Faskh Street, New York  
HPA Case # 5013-12 (NYA)  
County of New York, N.Y.

**MONTGOMERY COUNTY HISTORIC PRESERVATION COMMISSION**  
**STAFF REPORT**

<b>Address:</b>	23 Hesketh Street, Chevy Chase	<b>Meeting Date:</b>	10/10/12
<b>Resource:</b>	<b>Contributing Resource</b> Chevy Chase Village Historic District	<b>Report Date:</b>	10/3/12
<b>Applicant:</b>	John and Susie Lively (Neal Thomson, Architect)	<b>Public Notice:</b>	9/26/12
<b>Review:</b>	HAWP	<b>Tax Credit:</b>	None
<b>Case Number:</b>	35/13-12W	<b>Staff:</b>	Josh Silver

**PROPOSAL:** Rear addition

**EXHIBIT C  
PROPOSED DEMOLITION**

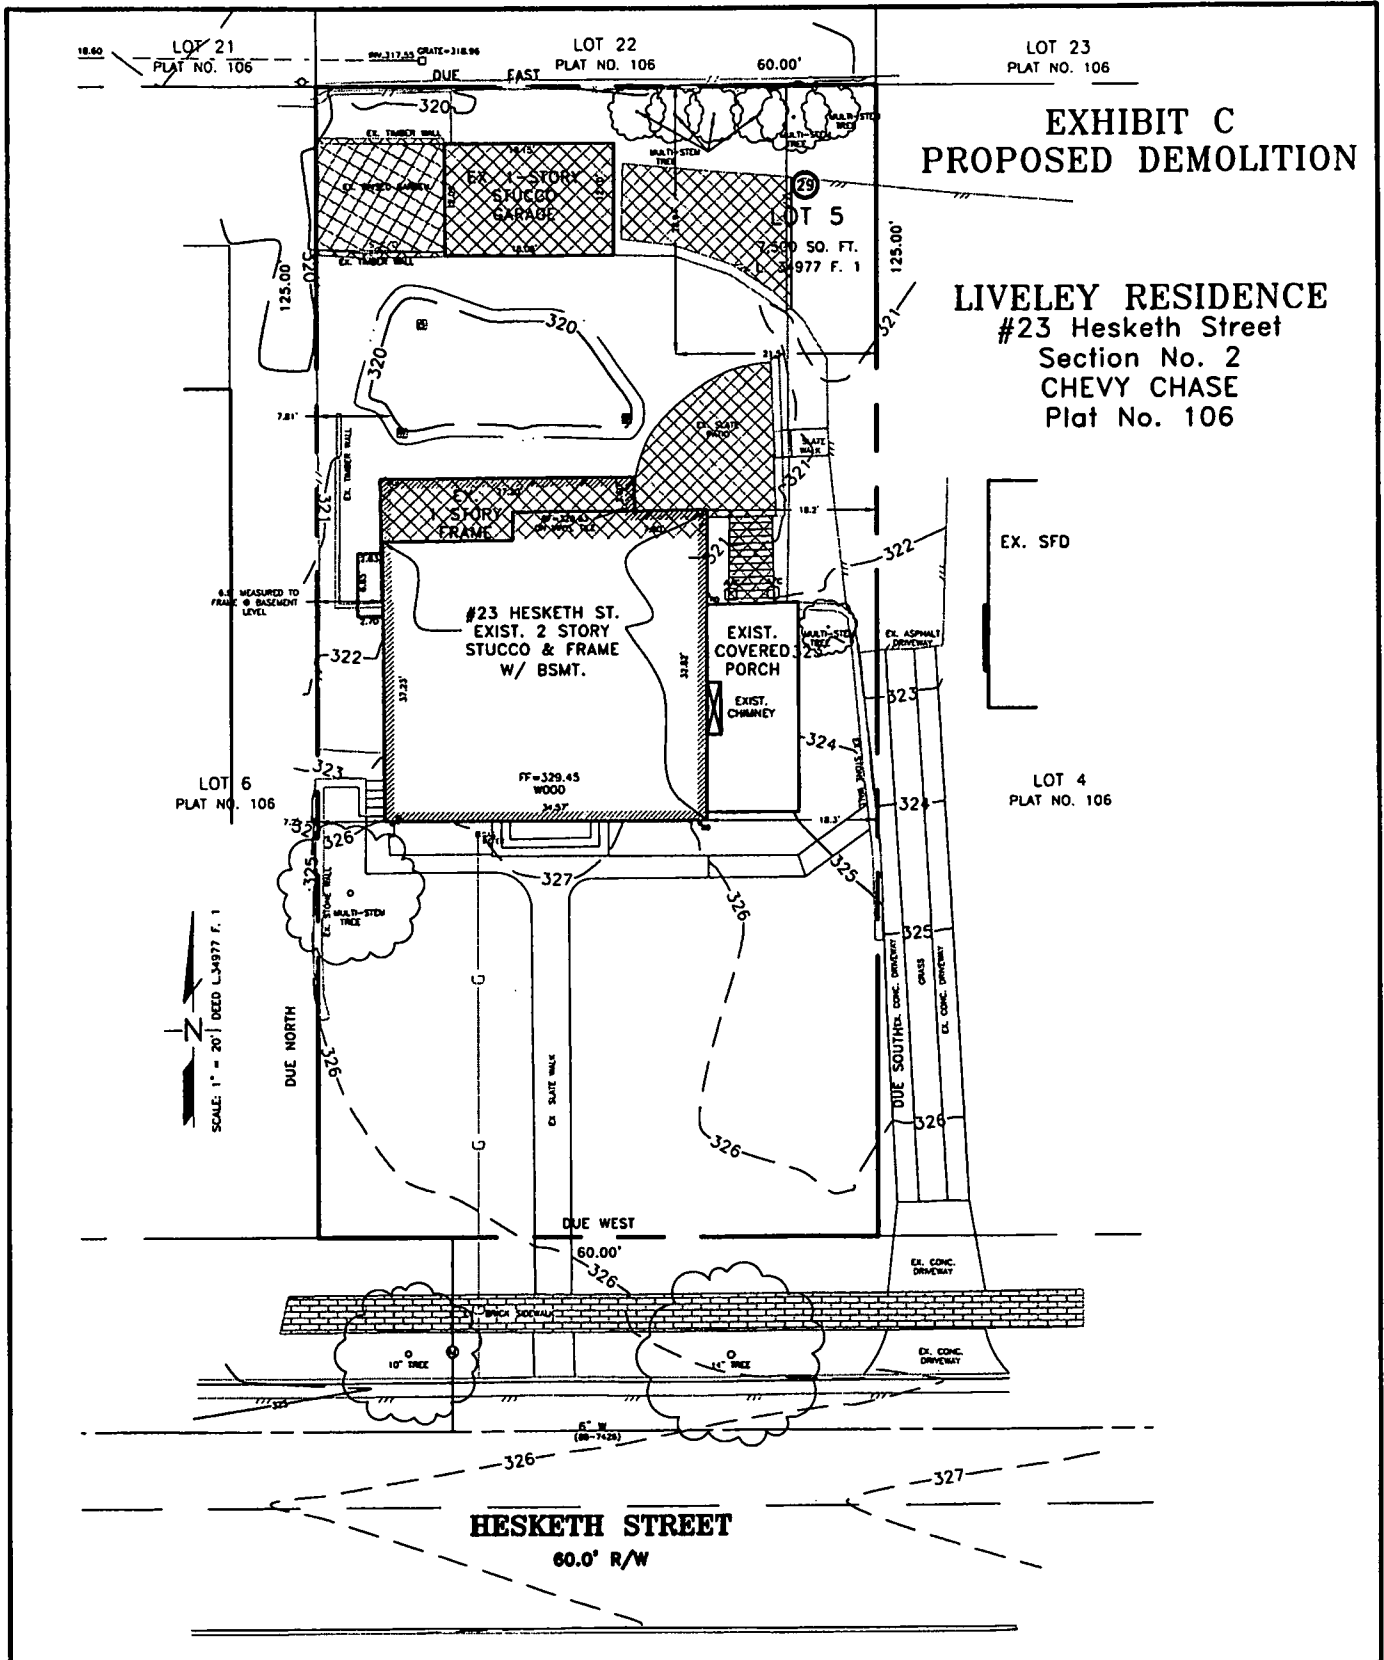
1. *Demolition of the existing 1 story rear yard garage is **not** approved.*

The proposed work also includes demolition of an existing (historic), 1 story garage located behind the main house in the rear yard of the subject property.

Staff finds that the demolition of the existing 1 story garage is not in keeping with the Standard #9. The proposed demolition would destroy an intact original historic feature of the property, its associated historic materials and the spatial relationship with the main house. Staff recommends that the HPC deny the applicants proposal to demolish the garage.

Staff recommends that the existing 1 story rear yard garage be preserved. The subject garage remains relatively intact; the only obvious alteration is a non-historic overhead door on the front elevation. Based on remaining physical evidence the door was likely installed within the original door opening. The primary construction material is stucco similar to that on the main house. The side elevations include either original or older 2/2, double-hung, wooden windows. The subject garage is identified on the 1927 Sanborn Fire Insurance Map in its current location. Despite the garage remaining largely intact, there is evidence of deterioration, specifically at the roof eaves, soffits and rake boards, which are rotted in certain areas and would require replacement.

**EXHIBIT B  
EXISTING CONDITIONS**

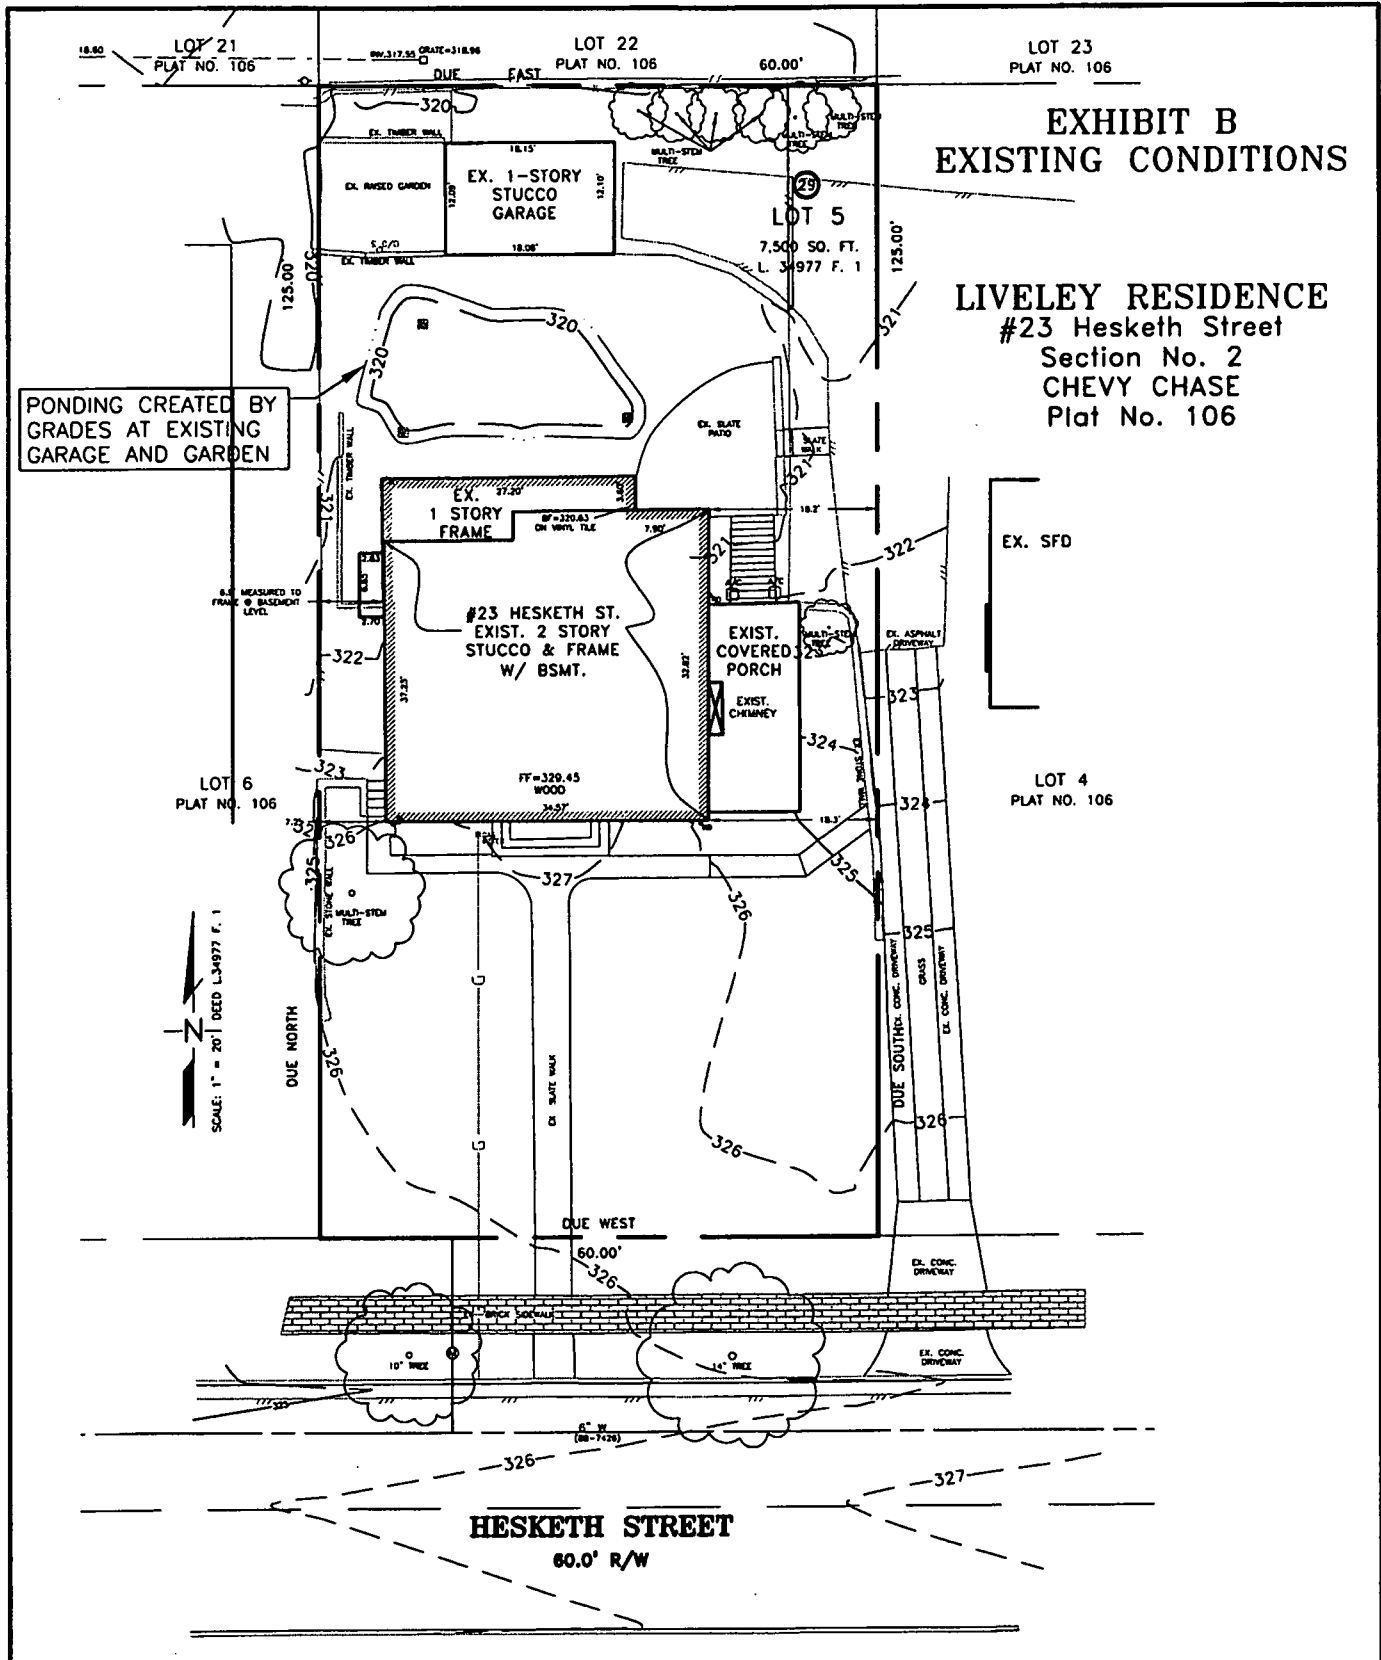
PONDING CREATED BY GRADES AT EXISTING GARAGE AND GARDEN

The current developed condition of the property is shown in Exhibit B, Existing Conditions. This lot with its two story house with a lower level basement slopes from Hesketh Street from Elevation 326 toward the rear of the property at approximately Elevation 320. In the rear yard there is an area between the house and garage that ponds water. Your plan, as we understand, is to demolish a small portion on the rear of the house to accommodate the new three level addition and also to remove the garage and part of the existing driveway serving that garage. This demolition is shown on Exhibit C, Proposed Demolition. This would allow the regrading of the rear of the lot to have a much better surface drainage slope between 3 – 4% as shown on Exhibit D, Proposed Conditions. Thus the demolition and regrading proposed eliminates the ponding area in the rear yard and also reduces the impervious cover of the garage and driveway, thus allowing much more green space in the rear yard.
